Access Compliance Report

Public Rights-of-Way

(Curb Ramps)

Intersection ID: 5454	Main Street: PAVILION_BV	Cross Street: UNIVERSITY_CITY_BV	Location: N
ADA ID: A70D46289DBF	Ramp Type: Perp	Initial Pass/Fail: Fail	Overall Compliance: No
Severity Score: 33.75			
Codes/Mitigation Info/Possible Solution		Field Measurements/Component Compliance

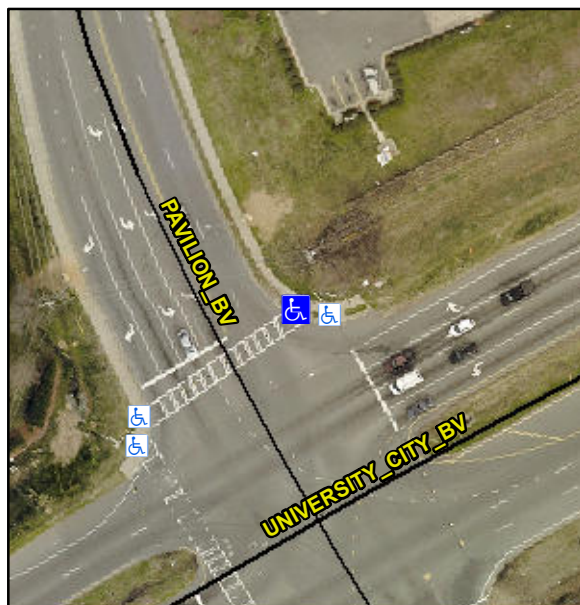
Not Found, R304.5.1, R304.2.2, R304.5.3

Compliance	Description	Data	Compliance	Description	Data
N/A	Ramp Length (in)	99.0	No	Ramp Slope (%)	9.5
No	Ramp Width (in)	47.0	No	Ramp XSlope (%)	5.9
N/A	Flare Type LT	N/A	N/A	Flare Type RT	N/A
N/A	Flare Slope LT (%)	N/A	N/A	Flare Slope RT (%)	N/A
N/A	Flare Traversable LT?	N/A	N/A	Flare Traversable RT?	N/A
N/A	Landing Length (in)	N/A	N/A	DWS Provided?	N/A
N/A	Landing Width (in)	N/A	N/A	DWS Contrast?	N/A
N/A	Landing Slope (%)	N/A	N/A	DWS Length (in)	N/A
N/A	Landing X Slope (%)	N/A	N/A	DWS Full Width?	N/A
N/A	Landing Curb? (Y/N)	N/A	N/A	DWS Offset (in)	N/A
N/A	Shared Landing?	N/A			
N/A	Gutter Ponding?	N/A	N/A	Gutter Slope (%)	N/A
N/A	Gutter Lip Ht (in)	N/A	N/A	Gutter X Slope (%)	N/A
N/A	Painted X Walk1?	Yes	N/A	Painted X Walk2?	N/A
	X Walk 1 Direction	To SW		X Walk 2 Direction	N/A
N/A	X Walk 1 Width (in)	109.5	N/A	X Walk 2 Width (in)	N/A
	X Walk 1 Slope (%)	0.9		X Walk 2 Slope (%)	N/A
	X Walk 1 X Slope (%)	4.9		X Walk 2 X Slope (%)	N/A

Remove & Replace Entire Ramp.
